**Re: Wetland Boundary Peer Review  
 Lot A, Main Street  
 Reading, Massachusetts**

[LEC File #: TORea\21-375.02]

Wetland Boundary Review Sketch

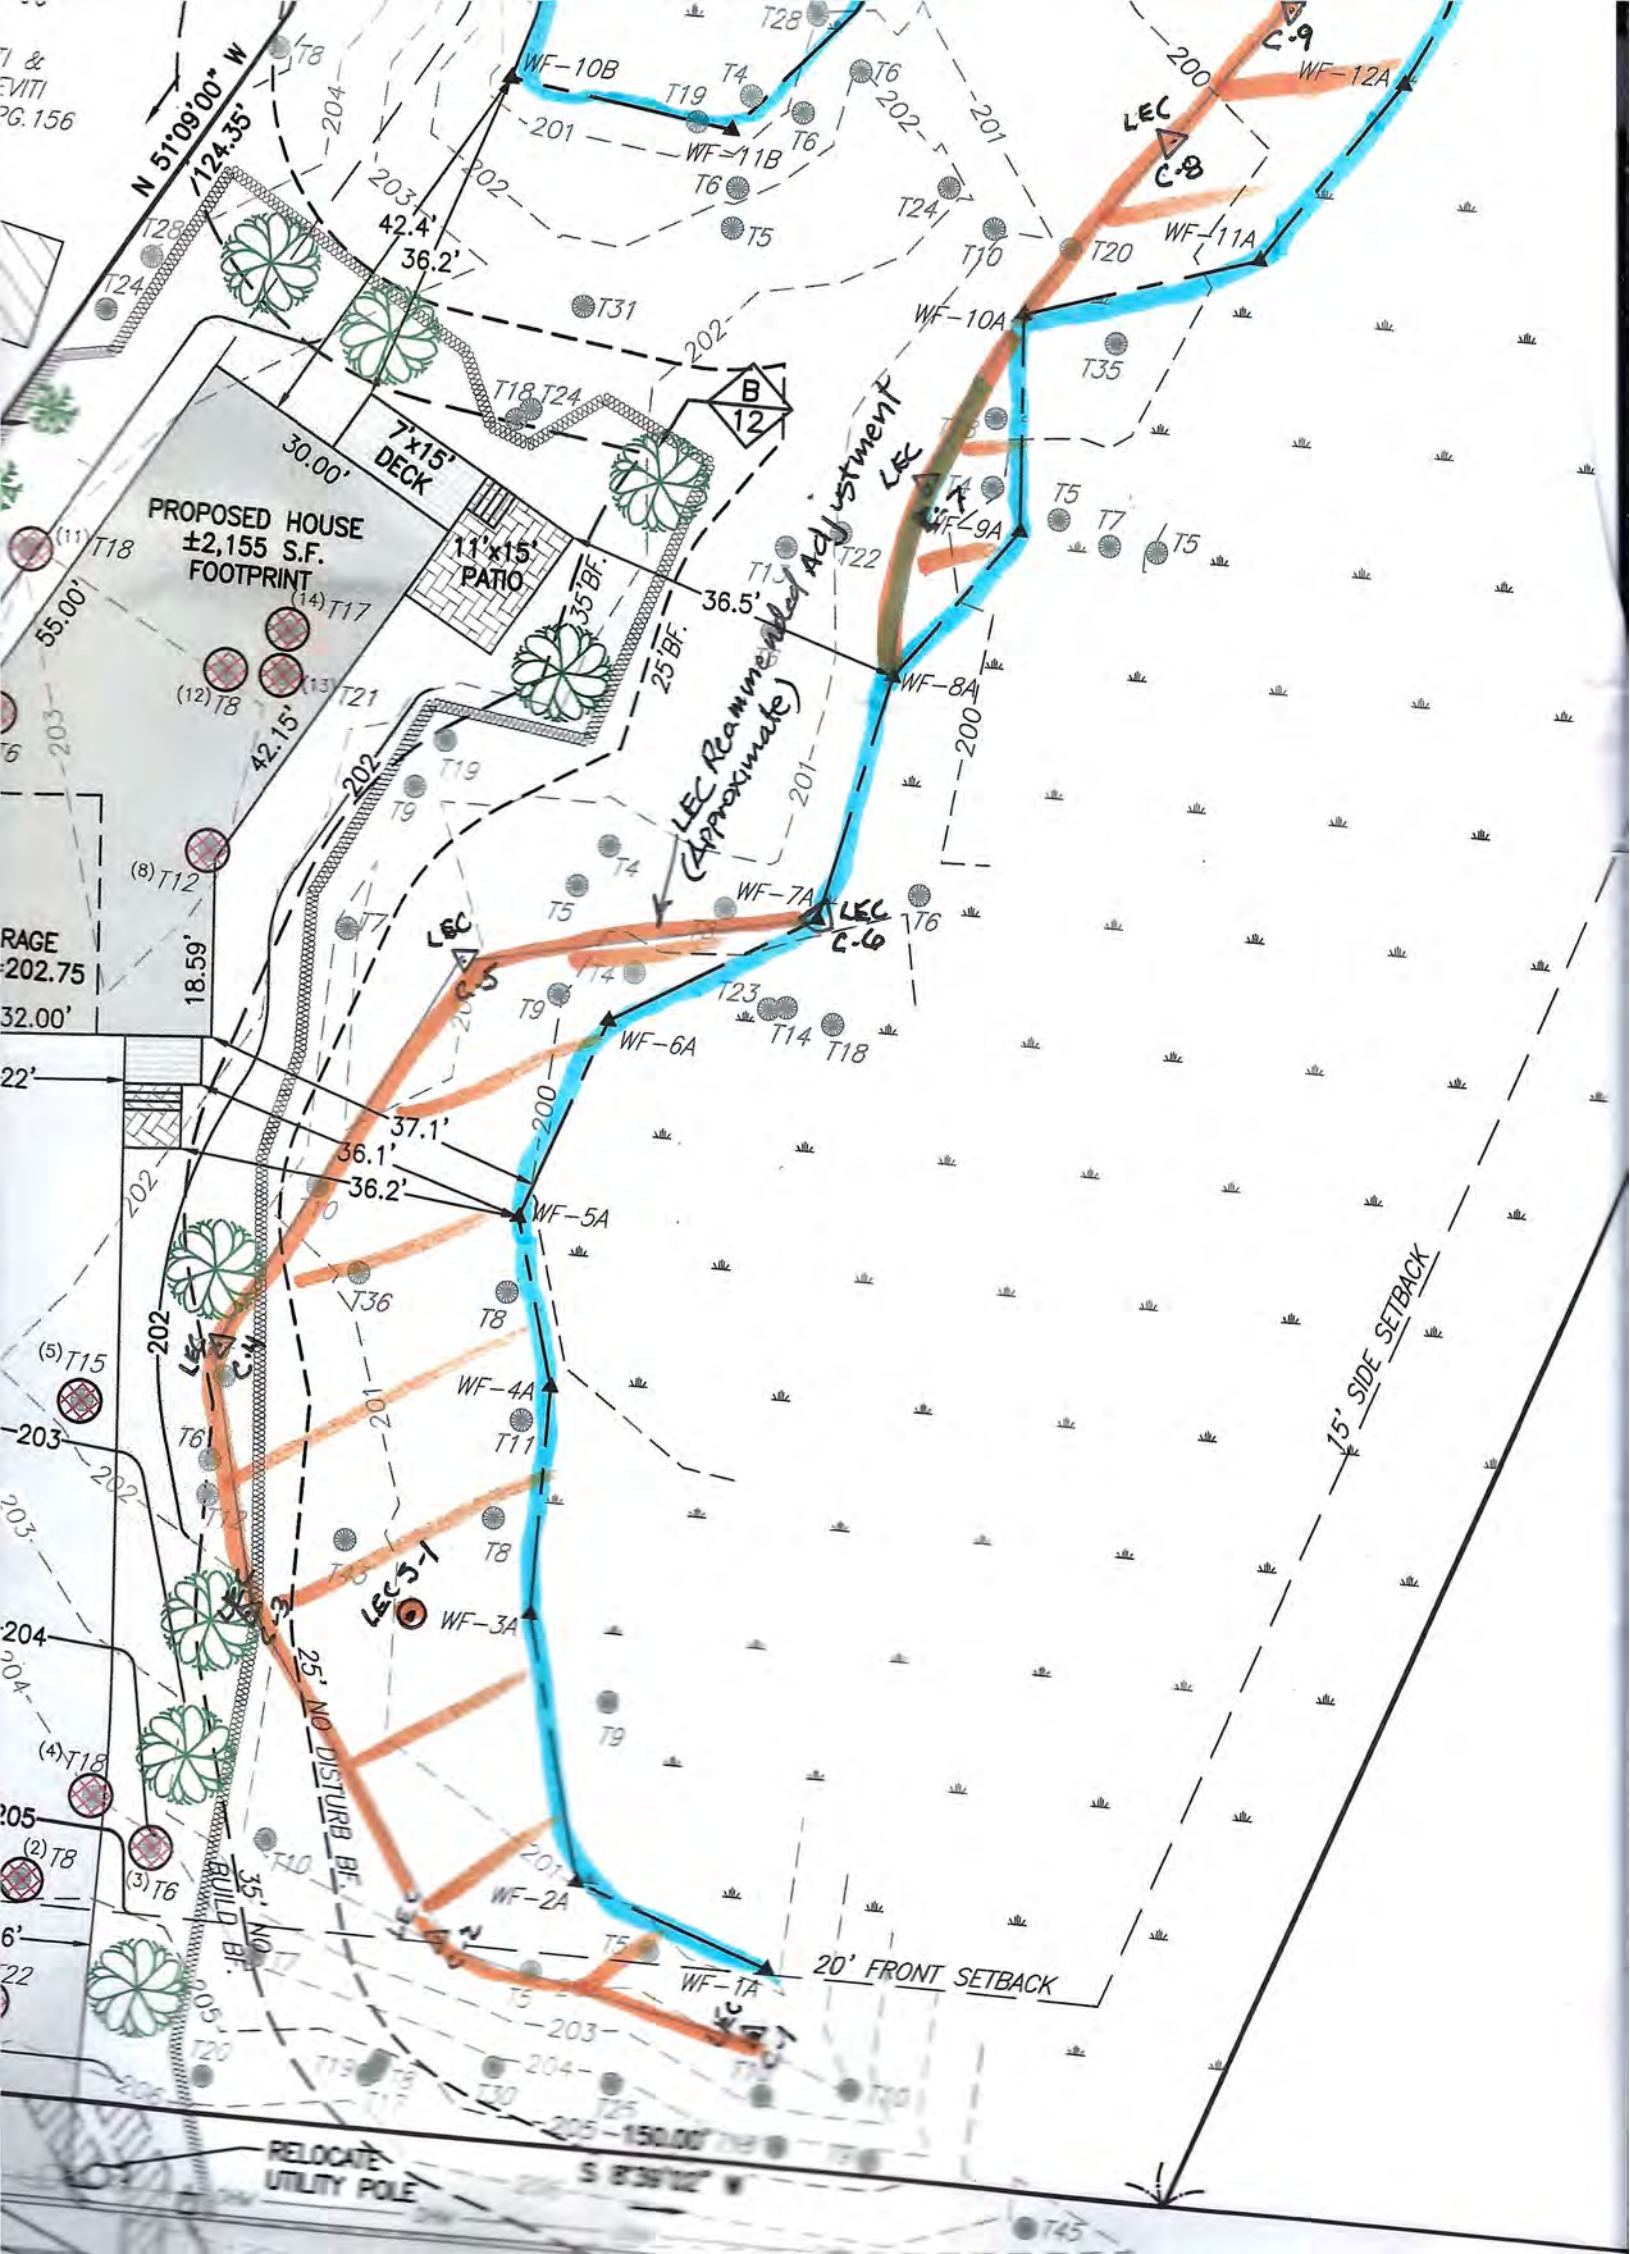
I found that the Scarborough soils and wetland plant community rise significantly higher on the landscape at the western end of the BVW delineation, than indicated by the NES delineation. To identify this expansion in resource area, LEC hung twelve orange flags, labeled “LEC Resource Area Delineation”, numbered “C-1” through “C-12”, up-gradient from the NES delineation. LEC recommended that the BVW delineation by NES be adjusted as indicated by the LEC flags and that the IVW be adjusted approximately 12 feet up-gradient from NES flag 8B, indicated by the LEC flag “8B-1”. These recommended adjustments were depicted on a hand-sketch, prepared by LEC and sent to the applicant’s consultant, Giovanni Fodera of Fodera Engineering, via email, on September 2, 2021.

Plant and soil data were collected at one point below the LEC adjusted BVW boundary (wetland) and one point above the boundary (upland), near LEC flag C-3. The data sheets (Attachment B) are representative of the entire BVW delineation and are attached as documentation for LEC’s recommended adjustments. The hydric soils that occur between the NES delineation and the adjusted LEC delineation meet hydric soil indicators A3 – Black Histic and A11 – Depleted Below Dark Surface<sup>1</sup>.

BVW Standing Water/Potential Vernal Pool Photos

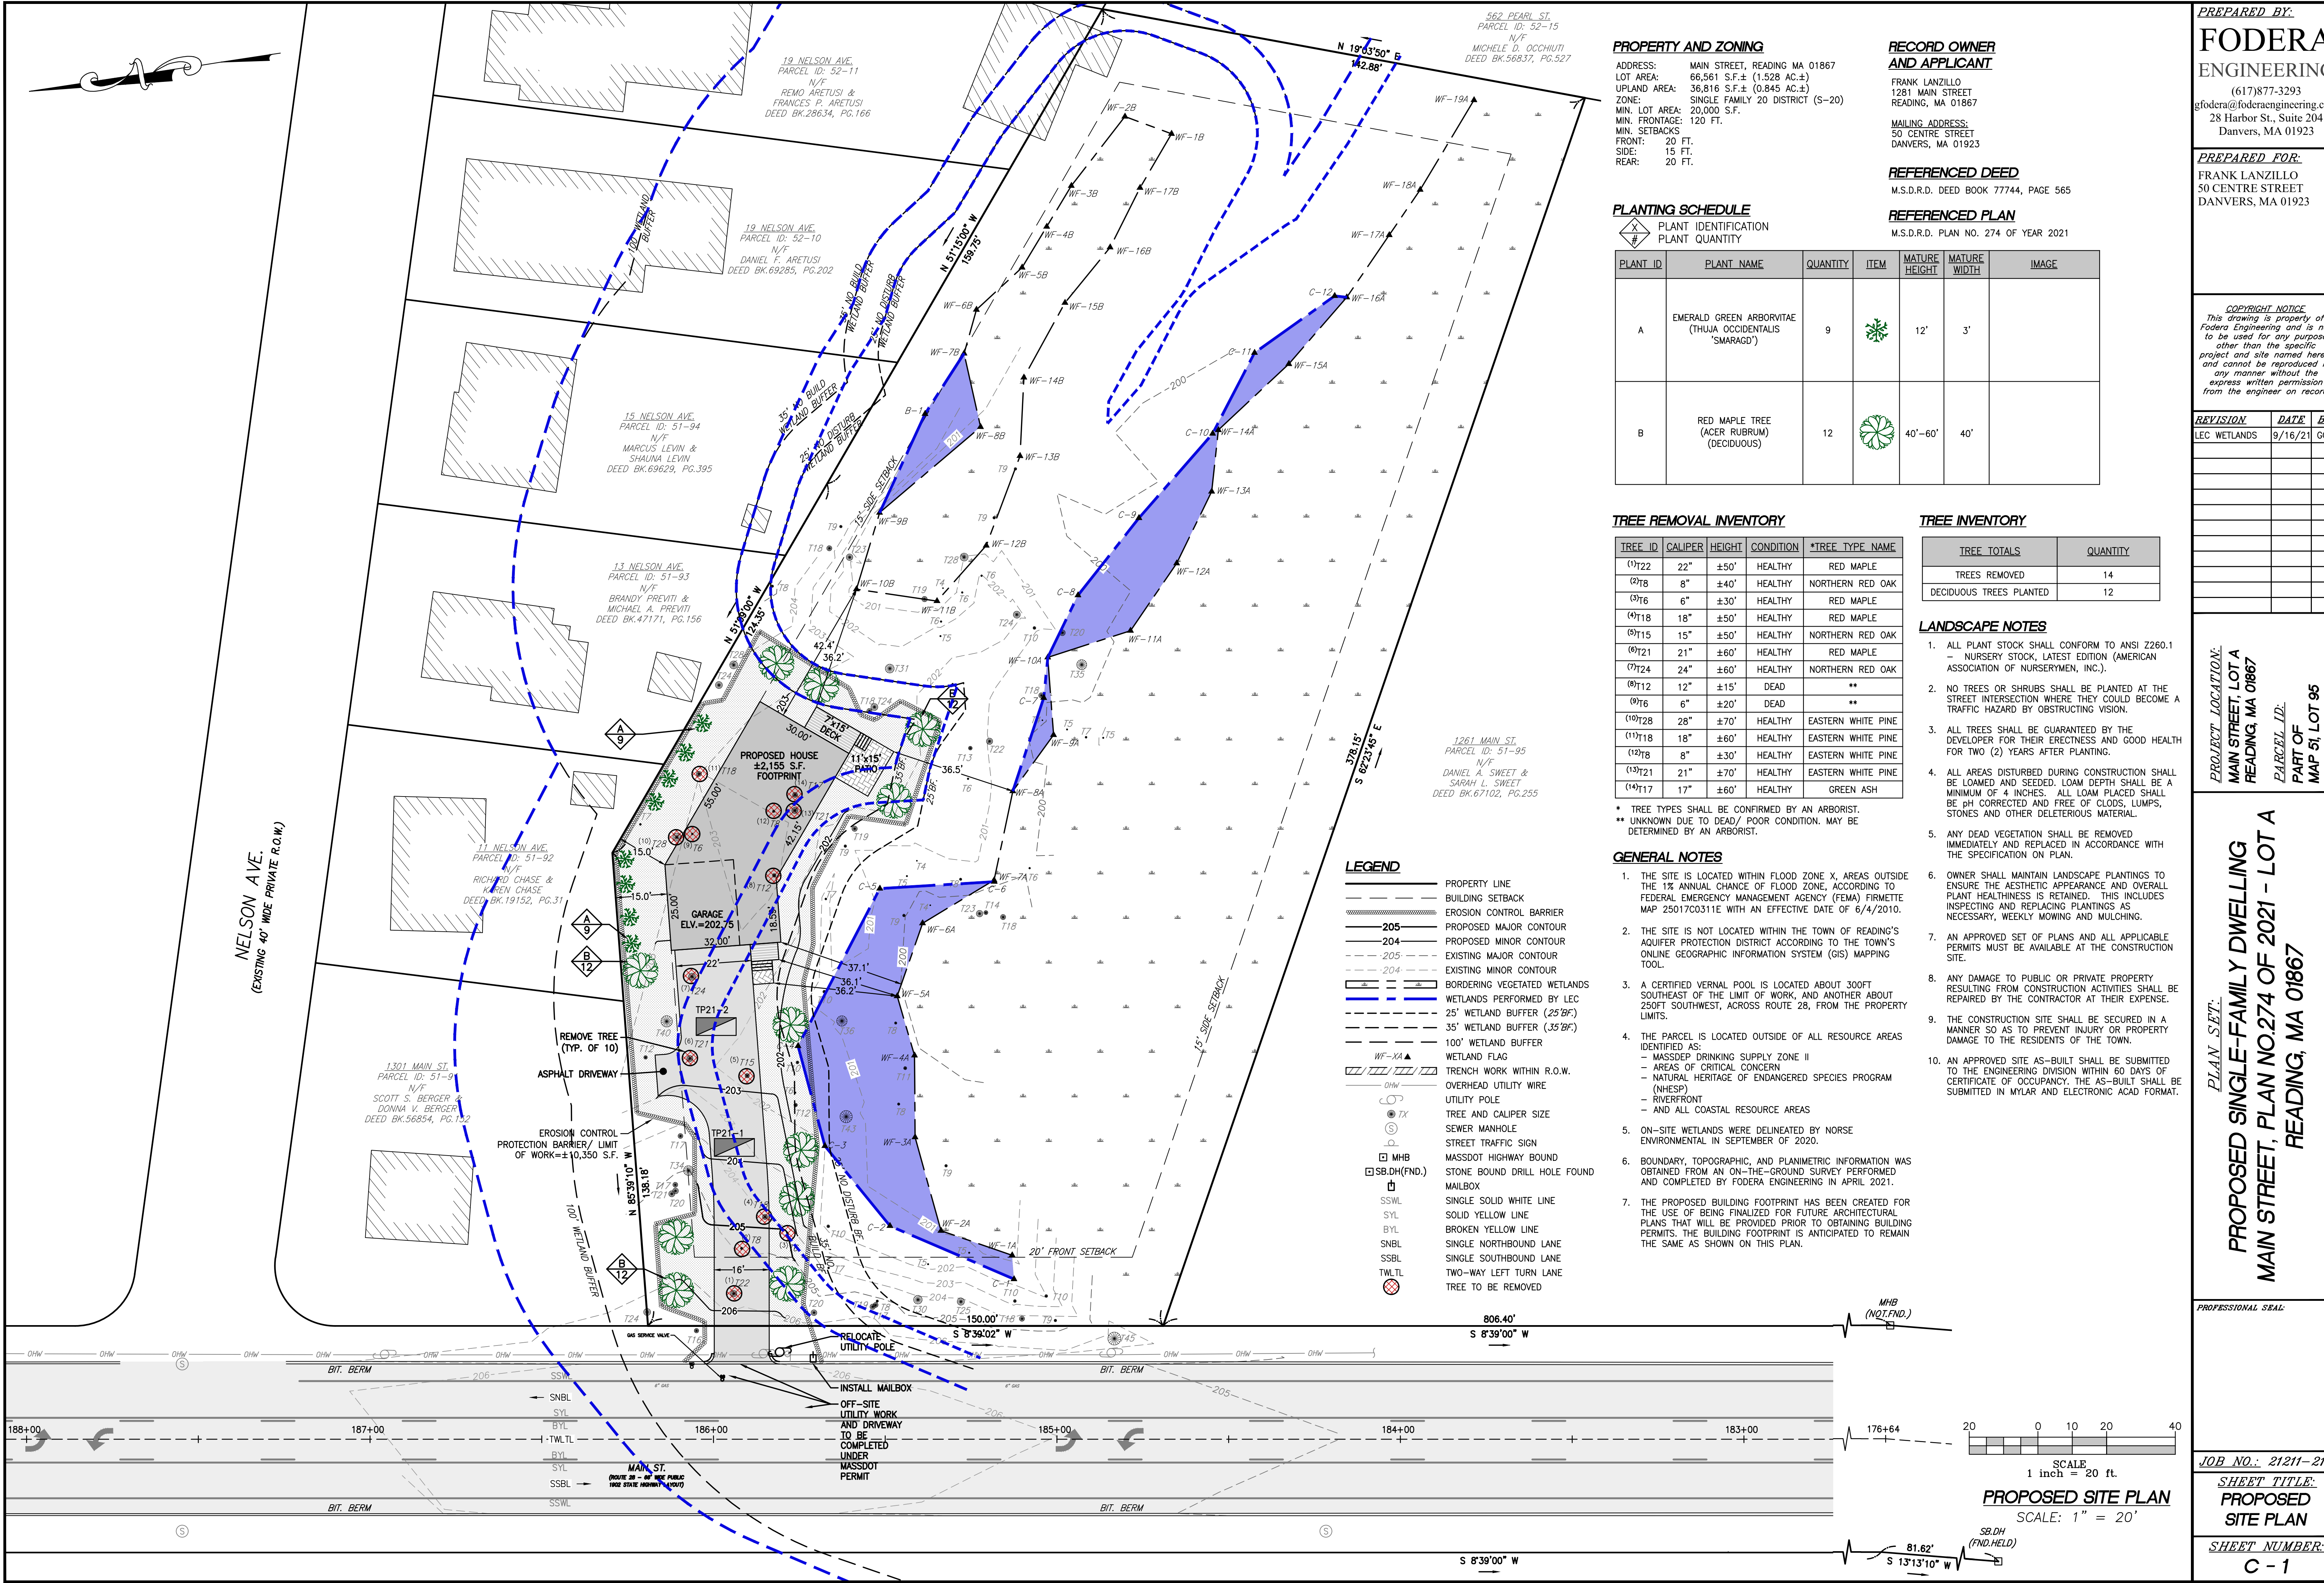
During the course of my review, I also observed standing water within the BVW approximately 50-feet 50 feet south of the NES BVW delineation (Attachment C). This portion of the BVW also may function as a vernal pool.

LEC concurs with the BVW and IVW delineations, as shown on the September 16, 2021 revised plan. The BVW is protectable under the *Act* and the *Bylaw*. The IVW, unless it qualifies as Isolated Land Subject to Flooding, is only protectable under the *Bylaw*. The standing water observed south of the BVW delineation, may function as vernal pool.
